CGt Series 1

Gas-Fired Water Boiler

Addendum Boiler Manual

Revised three-way valve installation and related documentation.

The following picture replaces the one shown on page 3 of the boiler manual.

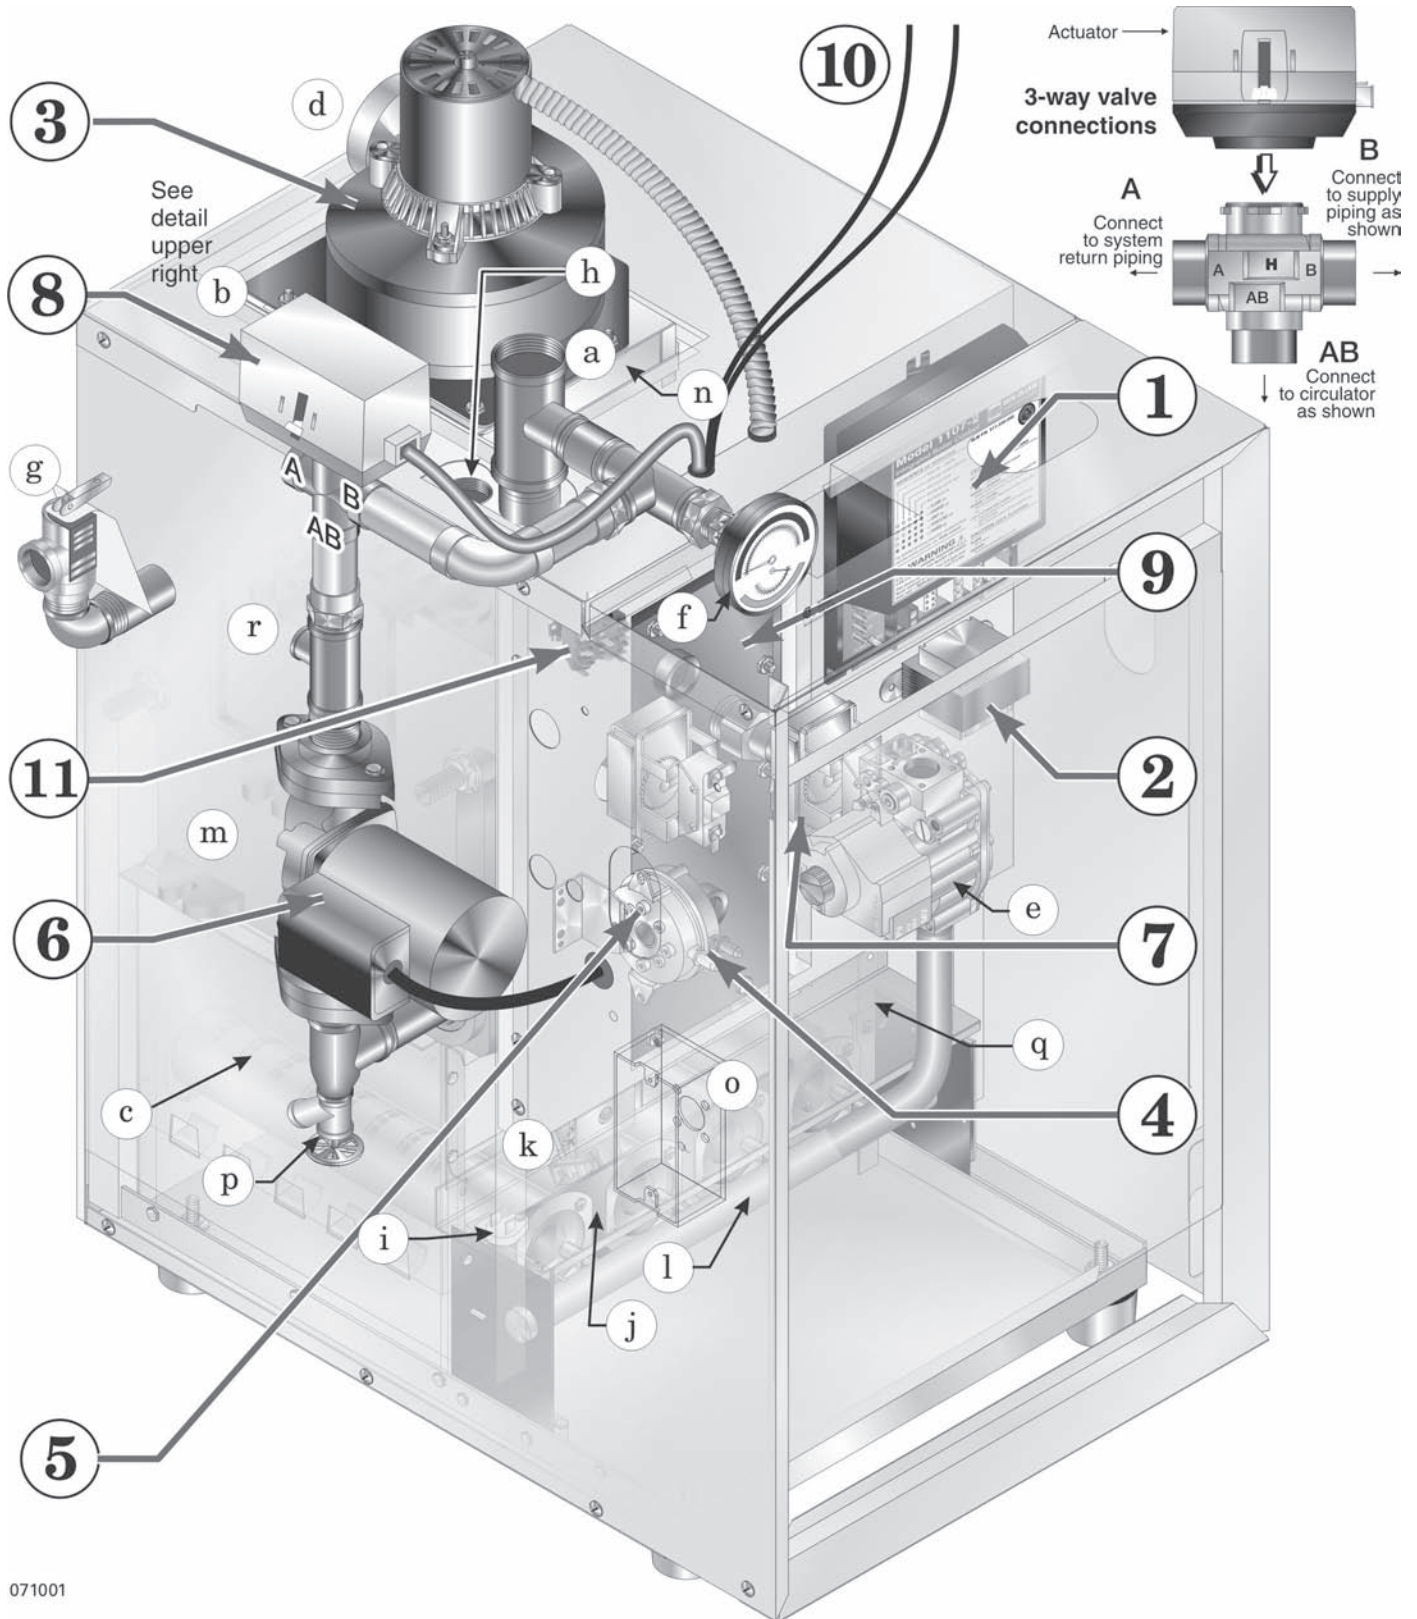
For page 3, the illustration has been changed to show the correct orientation of the 3-way valve and the addition of the relay on the interior panel.

1. The change is the reversing of the orientation of the 3-way valve body (A - connects to system piping and B - connects to supply piping as shown).
2. The addition of the relay Item 11, mounted on the interior panel.

The wiring diagram shown below supersedes the diagram on page 35 of the boiler manual.

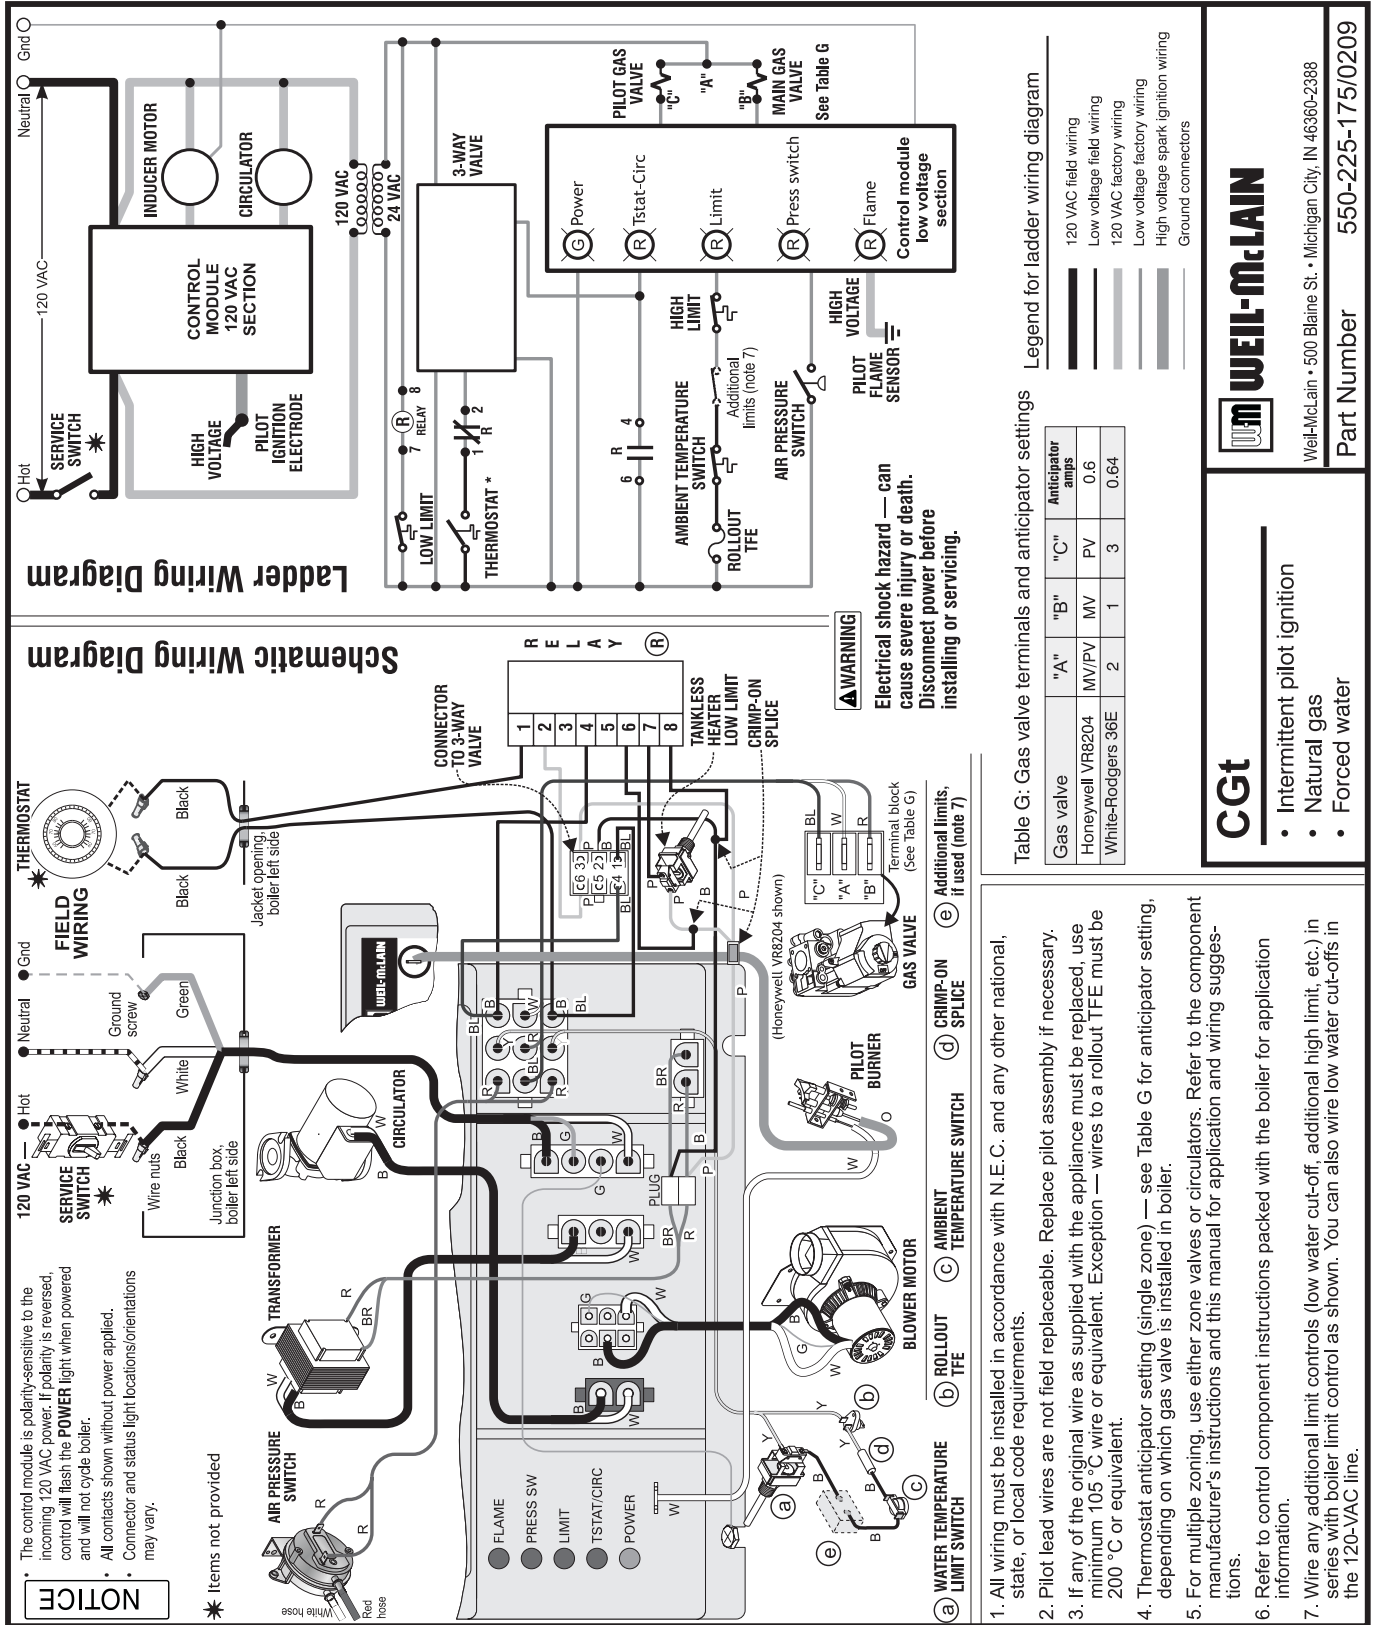
For page 35, the wiring diagram has been changed to show the addition of the relay.

3-Way valve

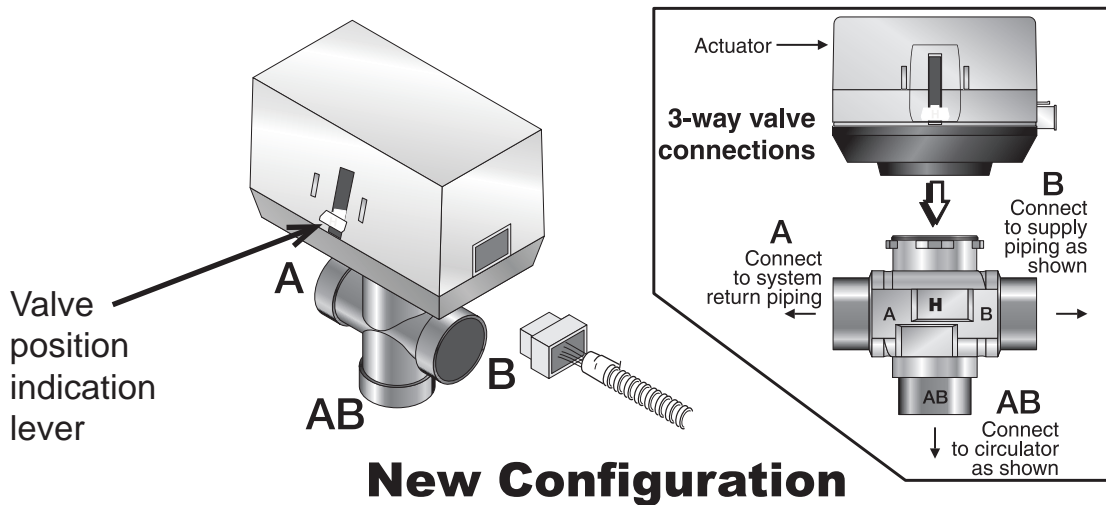
For page 47, the first paragraph under “3-way valve” has been updated.

The following information replaces the first paragraph under “**3-Way valve**” on page 47 of the boiler manual.

The 3-way valve redirects water flow in the circuit. Normally the valve allows water to flow through the bypass to maintain the heat in the boiler for the tankless heater. The 3-way valve lever is up in the normal position. When the heating thermostat calls for heat, the 3-way valve actuator lever drops which allows water to flow to the space heating system. Check for proper 3-way valve operation as follows:

Tankless operating limit calls for heat, boiler turns on when temperature drops approximately 10 degrees below tankless limit setting (differential). Boiler shuts off when temperature reaches tankless limit setting. The 3-way valve lever stays up all during domestic heating cycle.

Space heating thermostat calls for heat. 3-way valve lever drops and boiler fires providing space heat.
NOTE : If the boiler temperature drops below tankless limit setting minus 10 degree differential, the 3-way valve lever will raise to reheat boiler to tankless limit setting. Then the 3-way valve lever will drop and boiler will resume providing space heating until thermostat is satisfied, boiler limit setting is reached, or temperature in boiler drops below tankless limit setting minus 10 degree differential.

The following picture replaces the one shown on page 48 of the boiler manual.

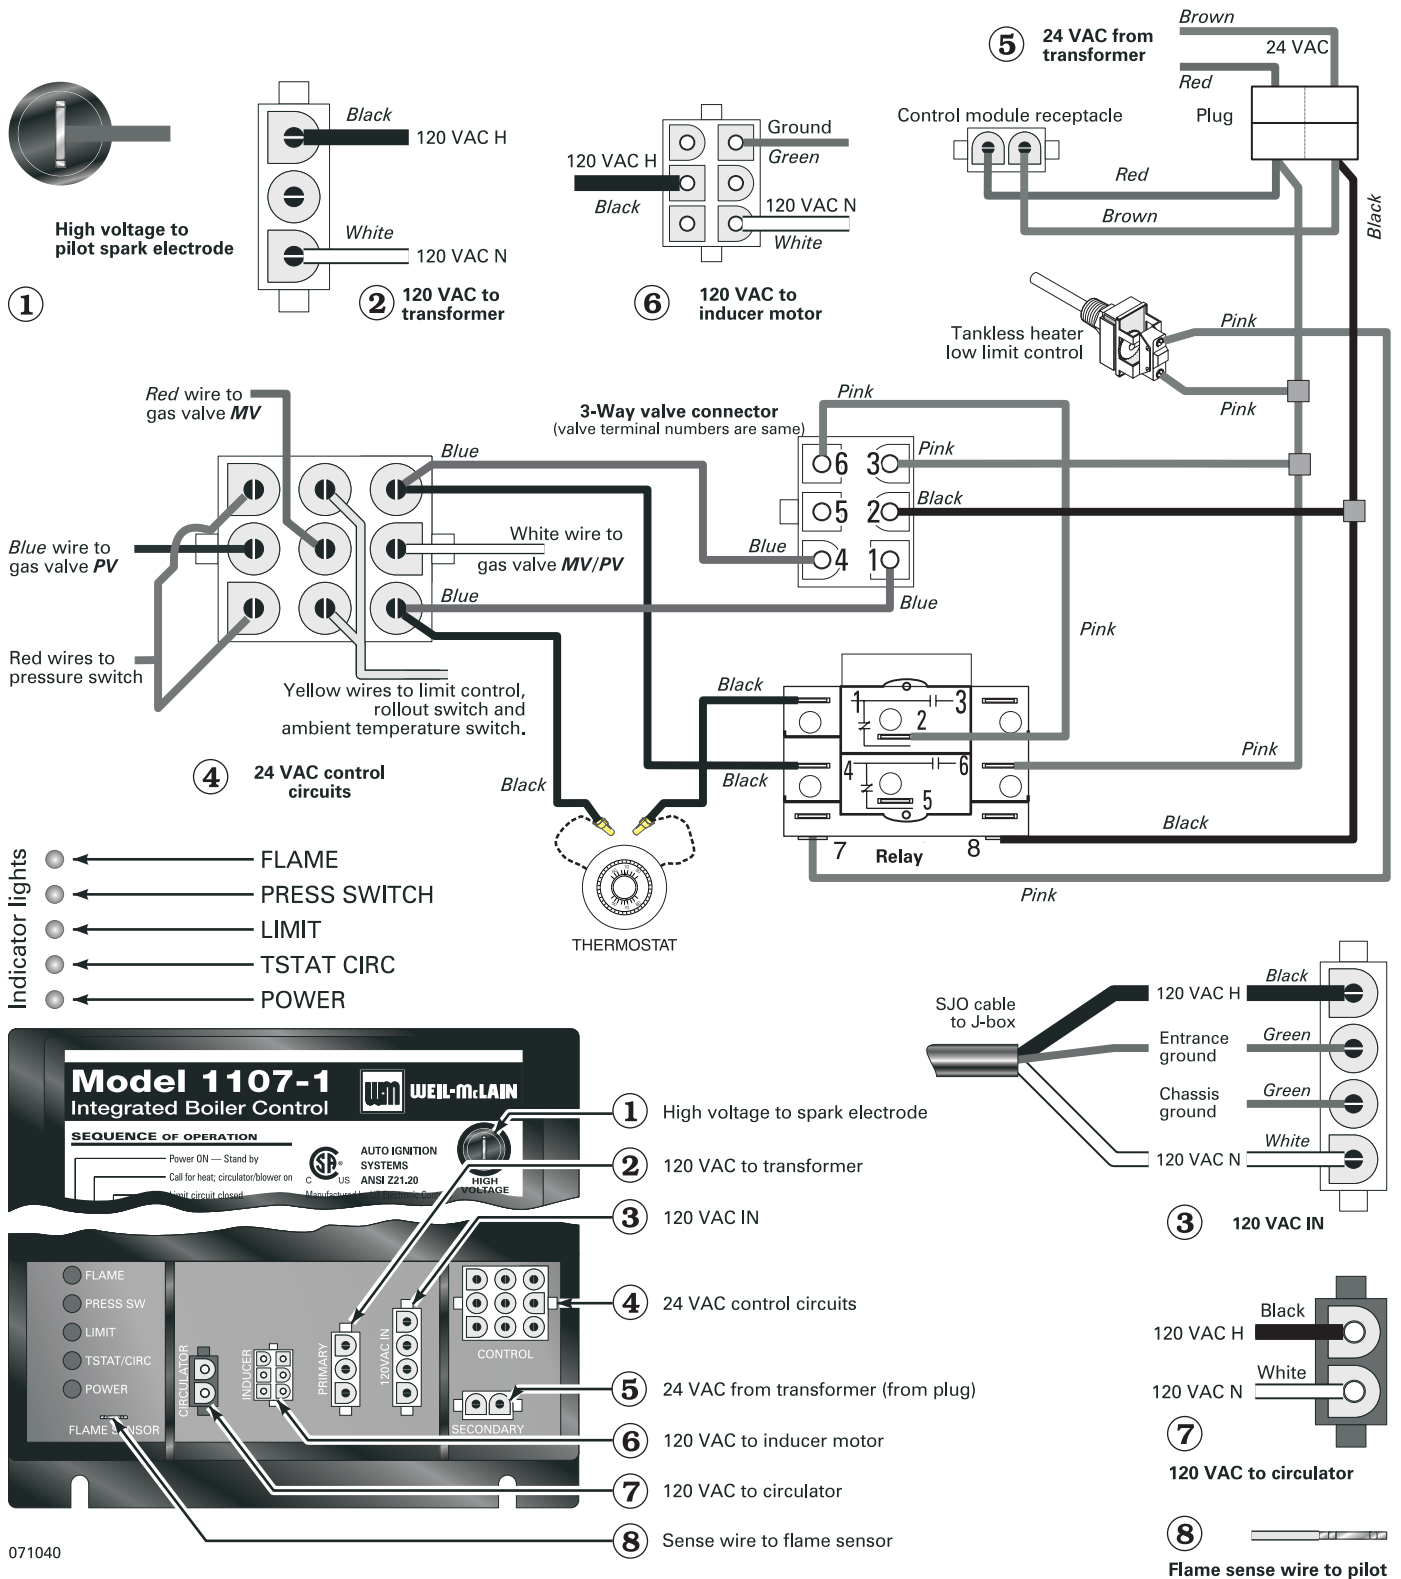
For page 48, the illustration has been changed to show the addition of the relay and thermostat.

Replace the drawings and tables found on pages 64 and 65 of the boiler manual with the following figures. The new information shows the new valve orientation and includes part information for relay used to control the valve.

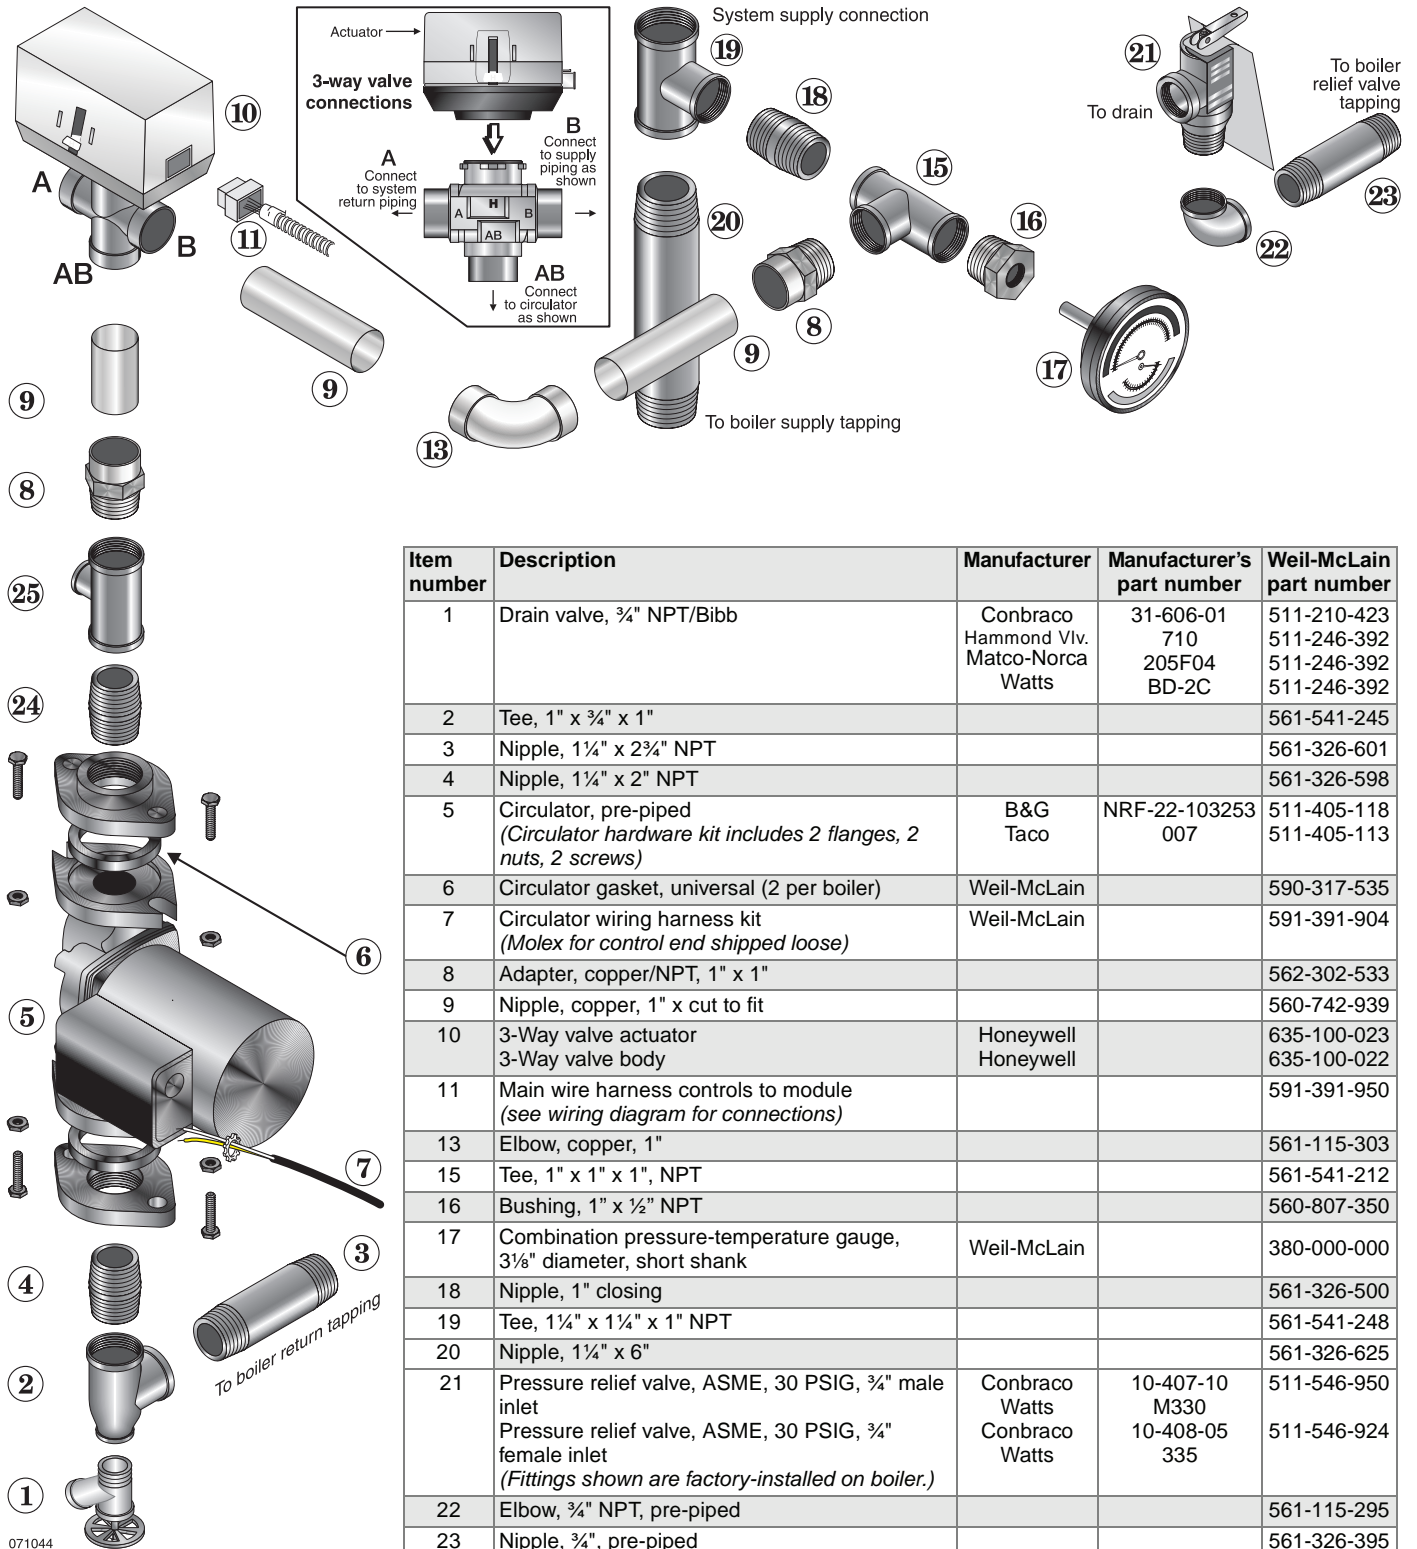
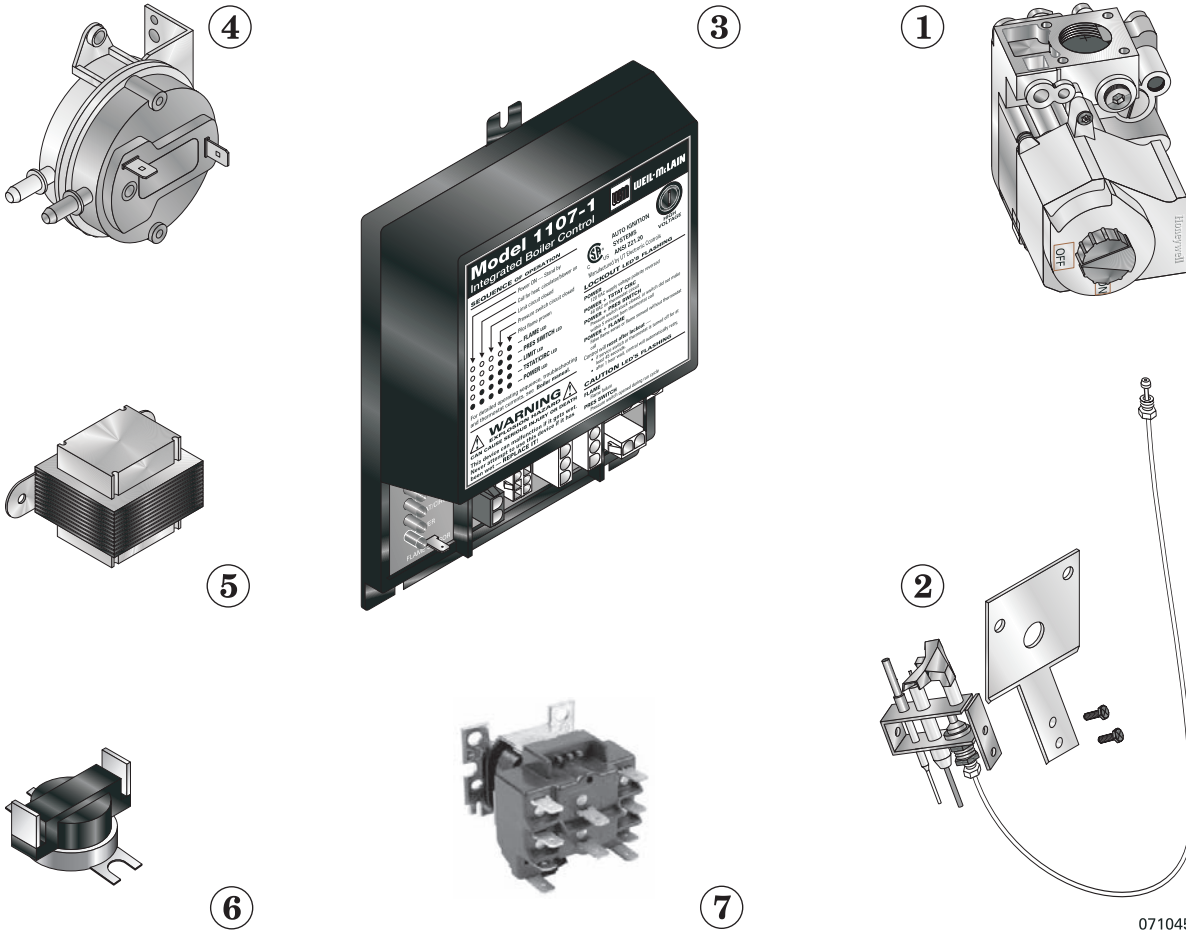
For pages 64 and 65, the illustration has been changed to show the correct orientation of the three-way and the addition of the relay part number to the replacement parts.
